INITIAL FIRE SAFETY INSPECTION REPORT

Factory Name: JEANS PLUS LTD. (EXTENSION)

RSC ID: 25789

Date: 14th Oct 2024

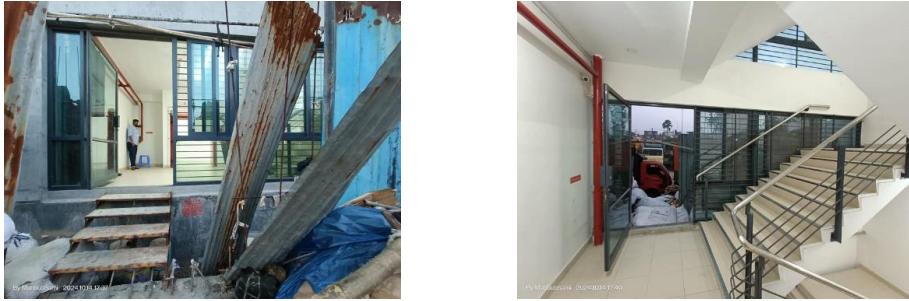
F-3	Fire Rated Construction	Areas used for combustible storage open to the factory are not separated by fire rated construction on 2nd, 3rd & 4th floors of Factory Building Extension.	Separate the dedicated storage rooms by minimum 1-hr fire-rated construction. Provide 0.75 hr. fire rated door and seal all penetrations and openings by 1 hr. fire rated fire rated barrier construction. Where separate storage rooms are not feasible, provide defined storage areas and limit the storage arrangement as follows: - Maximum height of 2.45m (8ft.) , maximum area of 23m2 (250 ft2) and 3m (10ft.) clear distance from adjacent another unenclosed combustible storage. - If the building/floor is sprinkler protected: maximum height of 3.66m (12ft.) and maximum area of 93m2 (1000 ft2) and 3m (10ft.) clear distance from adjacent another unenclosed combustible storage.	Within 3 months

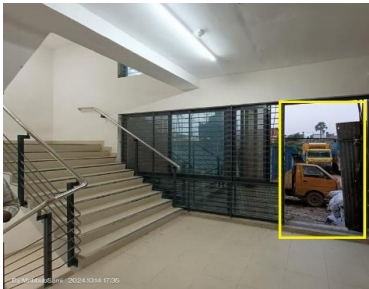
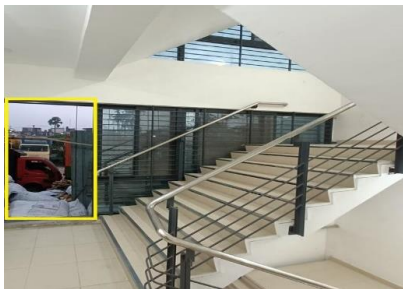
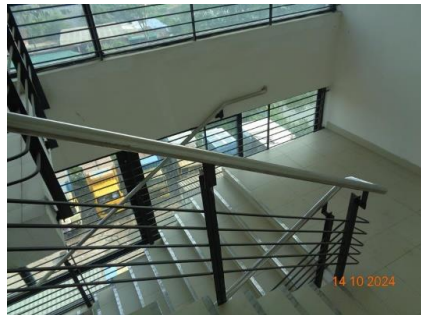
F-5	Fire Rated Construction	Expansion and contraction joints has been observed in between Factory Building Extension (ID-25789) & Old Factory Building (ID-10460). Location: Factory Building Extension and Factory Building.	Expansion and contraction joints provided to accommodate expansion, contraction, wind or seismic movement shall be protected with an approved material having the same degree of fire resistance as that of the wall or floor in which it is installed.	Within 3 months
